Findings of Fact | Wetland Conditional Use Permit

City of Portsmouth Planning Board

Property Address: 89 Cliff Rd.

RE: After-the-fact Wetland Conditional Use Permit Application #LU-24-54

1 SITE PLAN - WETLAND BUFFER IMPACT
1/8" = 1'-0"

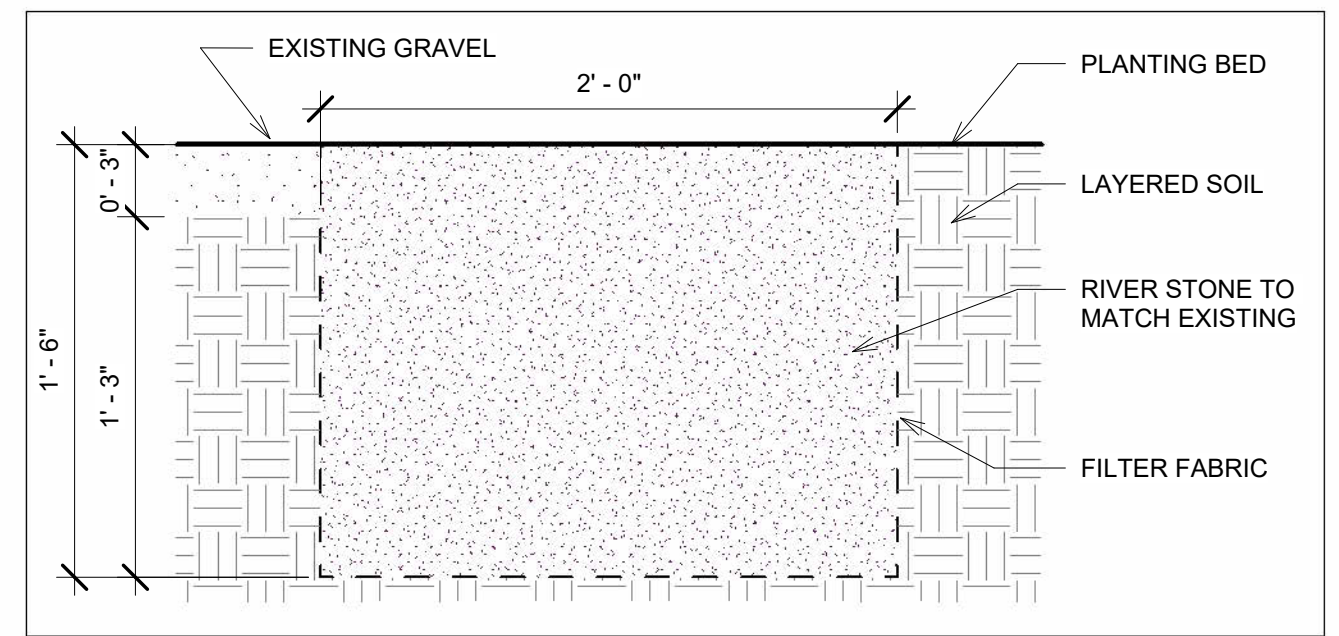
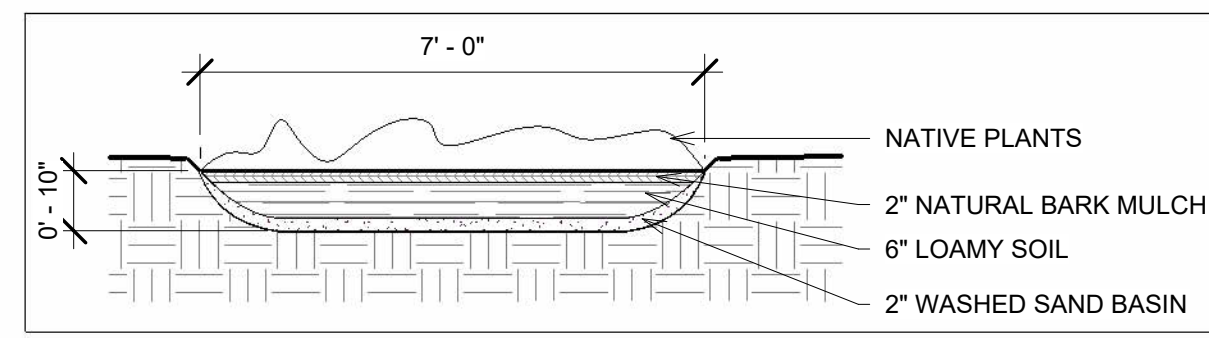
1. "Applicant shall change language on site plans for rain garden to recessed planting area and provide an update for the total area for planting and the number of plants proposed."

2. "Applicant shall work with City staff to incorporate changes suggested by the referenced Erosion Control Certified and landscaping experts, into final plan set prior to submission to the Planning Board."

- Revised Site Plan submitted to Planning Department and uploaded to portal 15 May reflecting requested language change, updated square footage of recessed planting area, and updated planting schedule.
- Separate document detailing updated planting schedule uploaded 15 May

- Site specific "Storm Water Management Best Practices" document submitted to Planning Department and uploaded to portal 15 May. Document prepared by Josh Stauble, Erosion Control Certified expert, Sea Change Land Services, York, ME.
- Recommendations from said document reflected in Revised Site Plan submitted 15 May, and services of Josh Stauble secured to supervise completion of same, highlighted below:
